# UNITED STATES PATENT AND TRADEMARK OFFICE

09/747,052

**Office Action Summary**

## DETAILED ACTION

Figure A

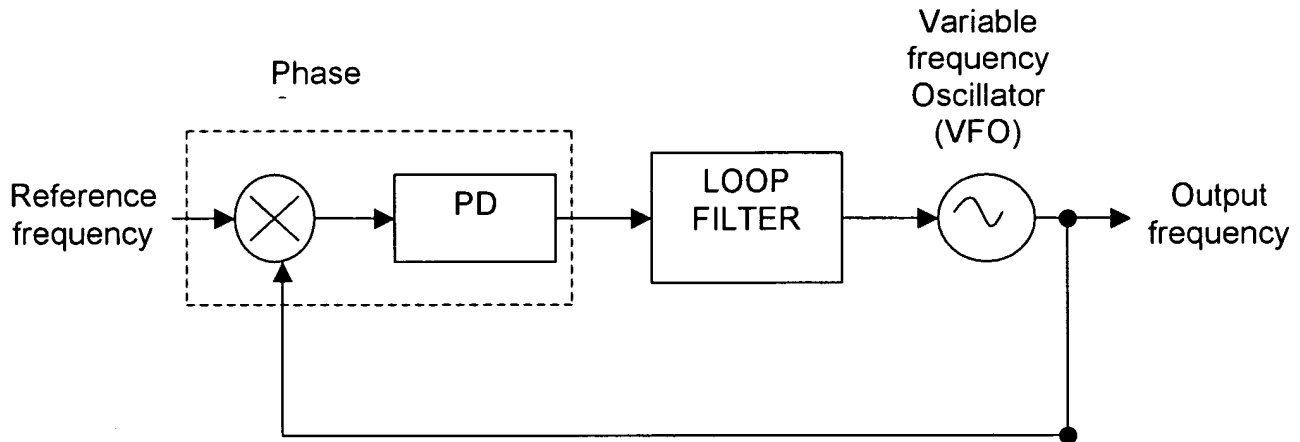
It is well known in the field of communication system that a PLL has the following structure (Fig.A ).

The PLL circuit is arranged to have a phase comparator being inputted with a reference frequency, a low-pass filter (or Loop filter), and a variable frequency oscillator (VFO). The output from the VFO is taken as a PLL output signal (frequency) at an output terminal as well as sent back to the phase comparator 102. **The VFO normally uses a voltage controlled oscillator (VCO) for the analog PLL, while for the digital PLL, the VFO uses an oscillator arranged to change a frequency dividing ratio according to input phase error information, such as a number controlled oscillator (NCO).**

In operating, the phase comparator operates to compare the PLL output signal with the input signal. Then, the compared result (successive phase difference values) is sent to a Loop Filter through which a dc signal corresponding to the phase difference is taken out. Based on the phase difference signal, the oscillating frequency of the

VFO is controlled so that the resulting PLL output signal takes synchronization with the input reference signal.

Figure B

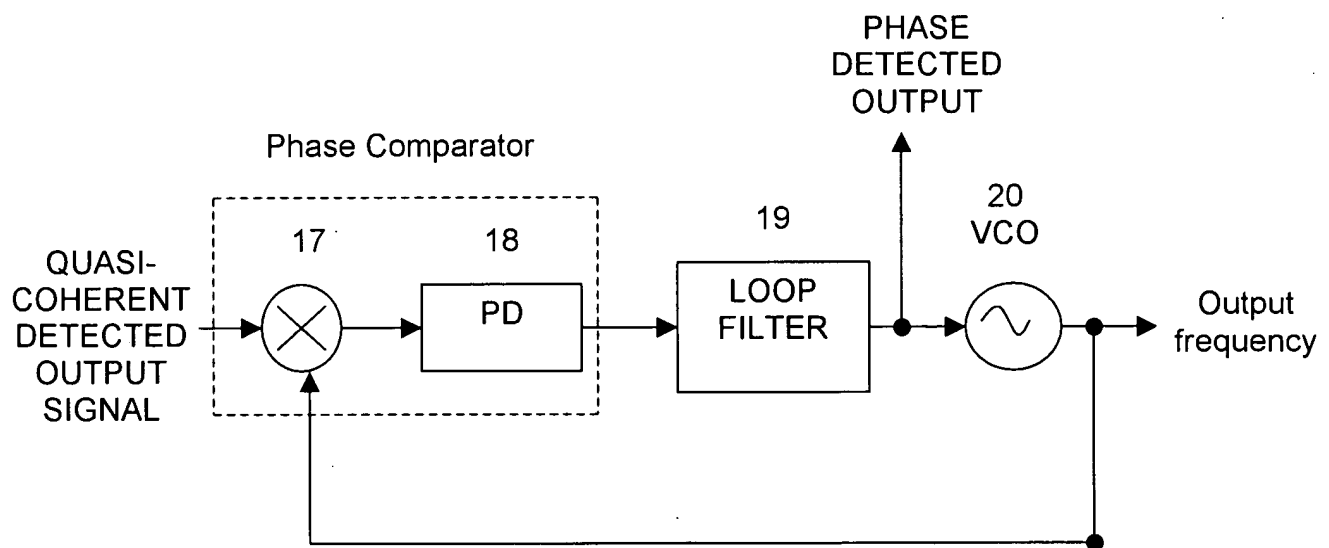
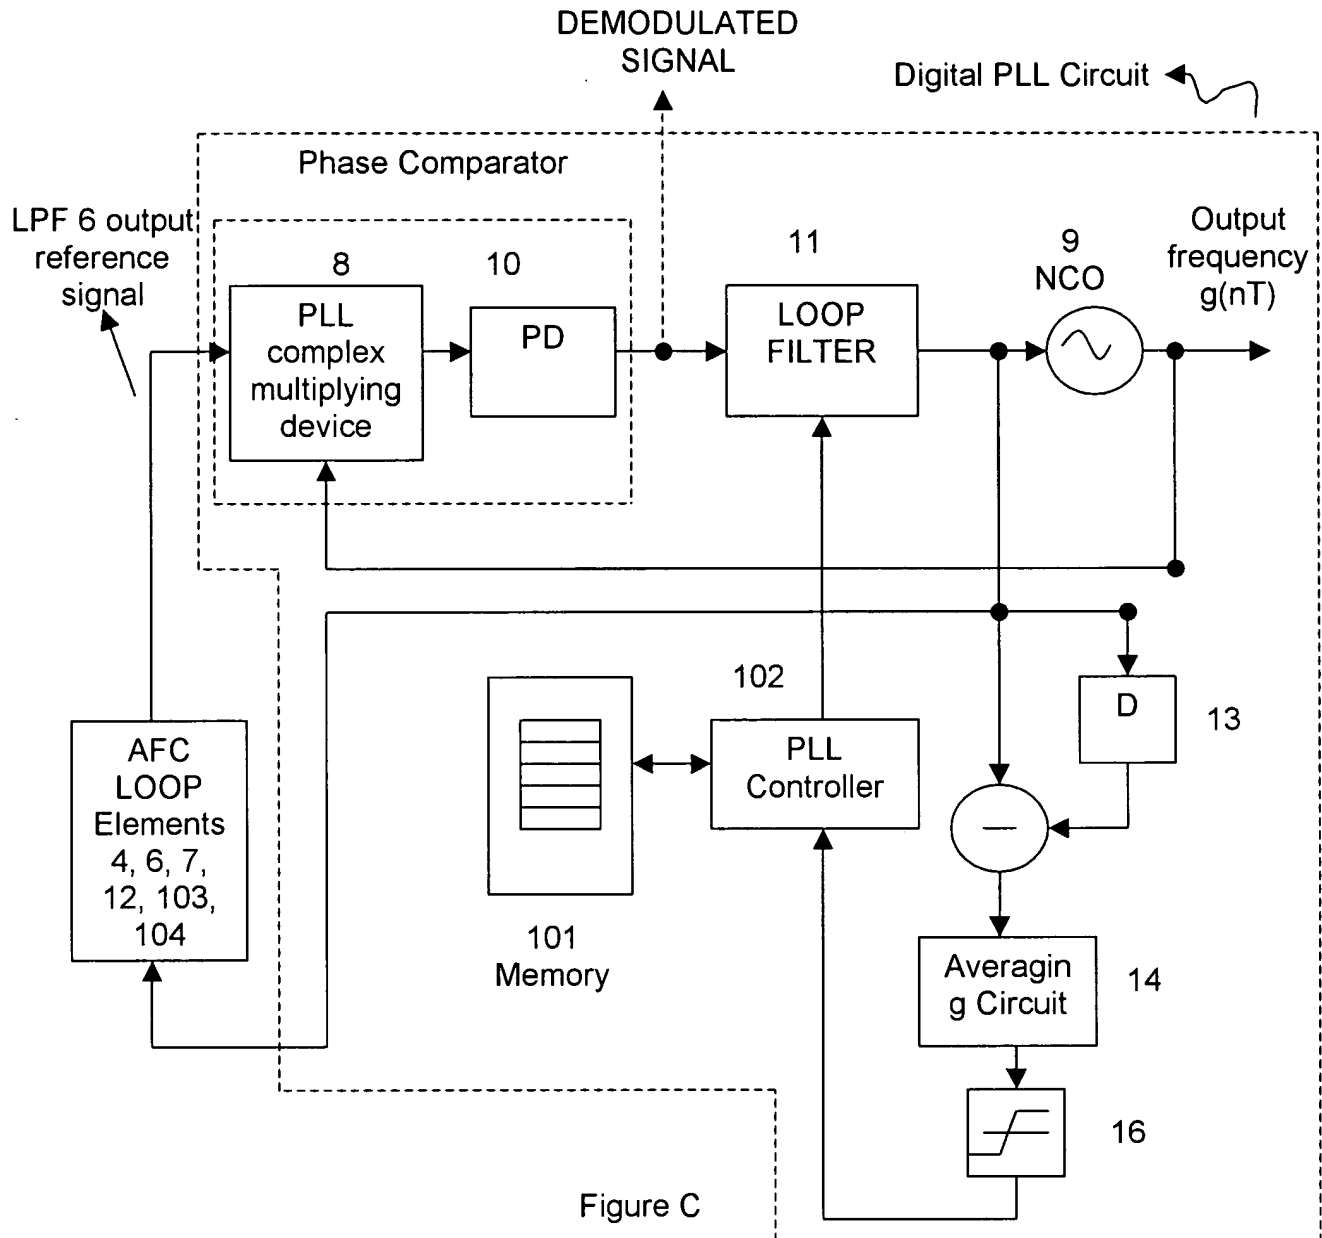
As shown in Fig.3, Tanaka teaches an analog PLL circuit (elements 17-20) with a voltage controlled oscillator (VCO) 20. Tanaka further teaches a digital PLL circuit (elements 8-11, 13-16, 101 and 102) with a numeric controlling oscillator (NCO) 26 in Fig.1. Fig.3 and Fig.1 of Tanaka's reference can be redrawn in the form of Fig.A basic PLL circuit block diagram as Figure B and Figure C, respectively. As we can easily seeing that both **Fig.3 and Fig.1** of the PLL circuits have the exact same structure as that of **Figure A as shown** above. That is, the **Fig.3 (Fig.B)** of PLL circuit is an analog PLL with a VCO and **Fig.1 (Fig.C)** of PLL circuit is a digital PLL with a NCO.

The operation of Fig.3 (or Fig.B) analog PLL is described in column 1 line 25 – column 2 line 6 and the operation of Fig.1 (or Fig.C) digital PLL is described in column 3 line 58 – column 4 line 18, column 4 line 43 – column 5 line 14, and column 5 line 40 – column 6 line 24 of the Tanaka's reference.

**Refer back to Fig.C, the NCO 9 output signal in not only with respect to NCO 9, but also with respect to the digital PLL.**

Applicant also argued that the output of the (loop) filter 11 is proportional to the oscillation frequency of NCO 9, rather than being a function of successive control values within the meaning of Applicant's claims. In response this argument, examiner refers to Fig.1 (Figure C) of the Tanaka's reference again. The adjustable loop filter 11 output  $g(nT)$  provides successive control values to the delayed element 13 and subtractor 14 and outputs a signal having a function of  $\Delta g(nT)$ , then the averaging circuit 15 averages the function of  $\Delta g(nT)$  signal. The data determining device 16 compares the averaged signal with a threshold and outputs the determined signal to the PLL controller 102 to select the parameters of the loop range, the frequency control width, and the control time interval of the PLL corresponding to the output signal of the data determining unit 16 so as to control the PLL filter 11 (column 5 line 42 – column 6 line 6).

As admitted in the applicant's argument, the loop filter 11 is updated as a function of  $\Delta g(nT)$  which is determined by a delaying device 13, a subtracting device 14, and an averaging circuit 15. Examiner cites column 5 equation 8 to show that the time change amount  $\Delta g(nT)$  is a function of the successive phase difference values  $g(nT)$  and a function of the delayed successive phase difference values  $g(nT-T)$ . i.e.  $\Delta g(nT) = g(nT) - g(nT-T)$ .
